Office Action Summary	Application No. 10/590,315	Applicant(s) PREDEBON, DYNA KELLIE	
	Examiner CARLOS LUGO	Art Unit 3673

DETAILED ACTION

attachment #1

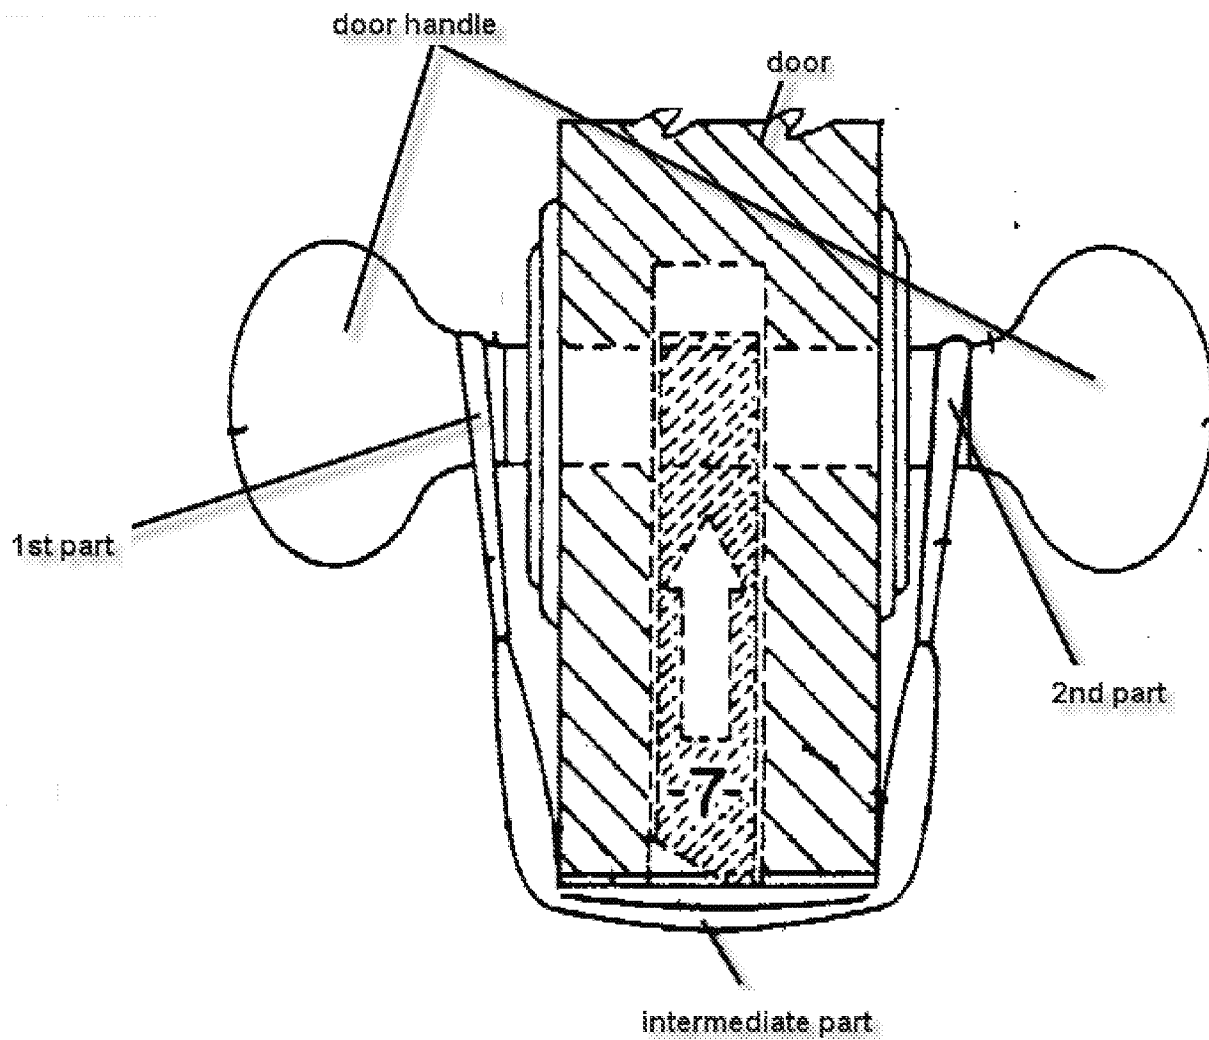
Radcliff discloses that the door may be closed within the door frame; not that is required. Further, as shown in Col. 2 Lines 35-50, first, in order to put the door within the door frame is required a significant force because of the friction exerted between the intermediate portion 11 and the door frame. In other words, is not easy to move the door within the door frame. Also, Radcliff cites that the chamber 14 of the body 11 is filled with stuffing 23. One of ordinary skill in the art could place sufficient stuffing into the chamber of member 11; enough to don't allow the door within the door frame (see attachment #2). Therefore, Radcliff is capable of preventing the door to be contained within the door frame.

attachment #2

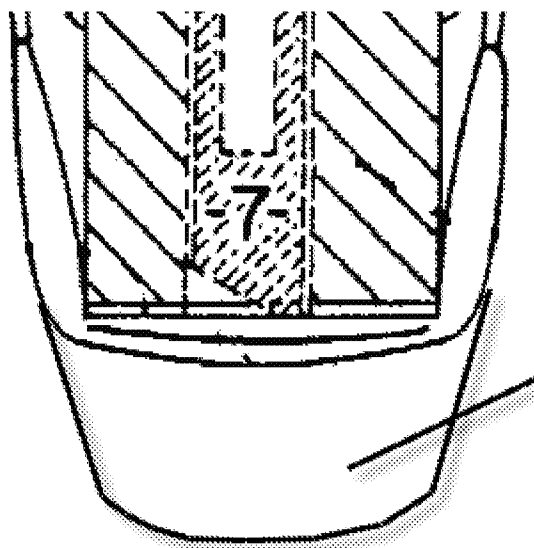
intermediate portion with
more stuffing
